Planning Commission Staff Report

MEETING DATE: DECEMBER 3, 2014

SUBJECT: Z14-24, BRIGHTON: REQUEST TO REZONE APPROXIMATELY 12.4 ACRES OF REAL PROPERTY GENERALLY LOCATED NORTH OF THE NORTHWEST CORNER OF VAL VISTA DRIVE AND ELLIOT ROAD FROM SINGLE FAMILY-35 (SF-35) TO SINGLE FAMILY-7 (SF-7) ZONING DISTRICT WITH A PLANNED AREA DEVELOPMENT (PAD) OVERLAY.

Figure 1

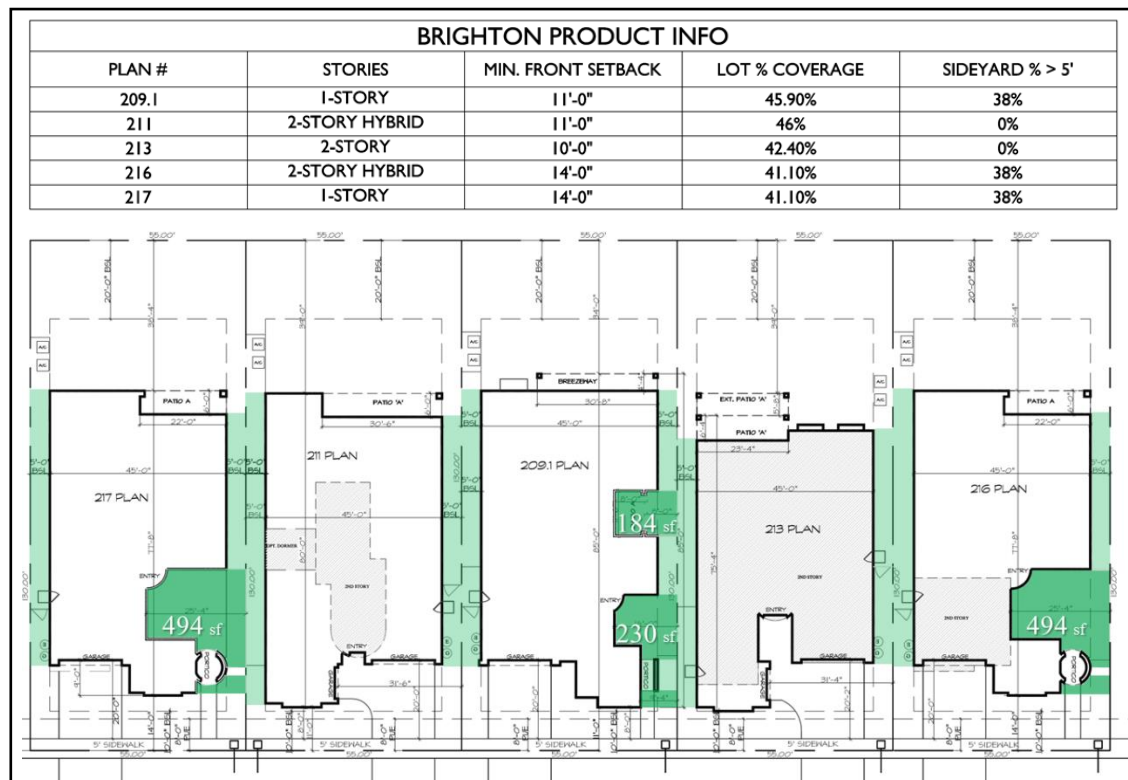
Concern #2 The effect of the proposed model plan series with regard to additional open space along the side-yards (as noted above) through notched-in private patio area is not clear in terms of functional or measurable benefit (ie, "What percentage of the side elevation is more setback more than 5'?").

Response #2 To mitigate the side-yard deviation request for 5'/5' side-yards; three of the five floorplan options will feature significant side courtyards, which expand the side-yards into highly functional and active spaces. The aforementioned models increase the setback from 5' for over 35% of the length of one side of the house. Figure 1 (next page) shows the proposed models and their percentage increase above the 5' minimum side-yard area. The following condition of rezoning is proposed to ensure this side-yard variation is achieved:

Development will provide three or more individual model types that contain a side-yard that exceeds 5' for at least 35% of the length of one of the model's side elevations.

Figure 2

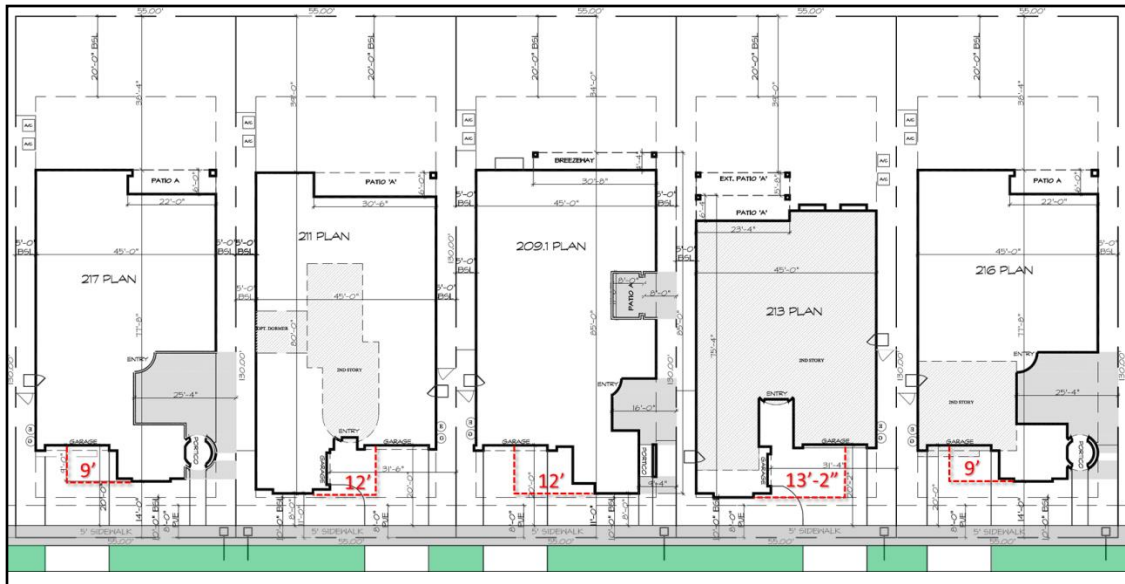
The effect of the proposed model plan series with regard to integral front setback staggering (in-lieu of the staggering system required by the LDC) is not clear in terms of functional or measurable benefit.

Response #3

All of the proposed model types provide an integral staggering (movement between massing of the front elevation) of the front façade that exceeds the LDC staggering requirement and therefore achieves the intent of this zoning provision. Figure 2 (next page) shows the measured difference in front setback proposed for each model type. The following condition of rezoning is proposed to ensure appropriate building setback staggering relative to the streetscape:

Each dwelling unit shall provide an 8-foot minimum setback stagger between the façade of the front-entry garage and the façade of the projecting livable area or side-entry garage.
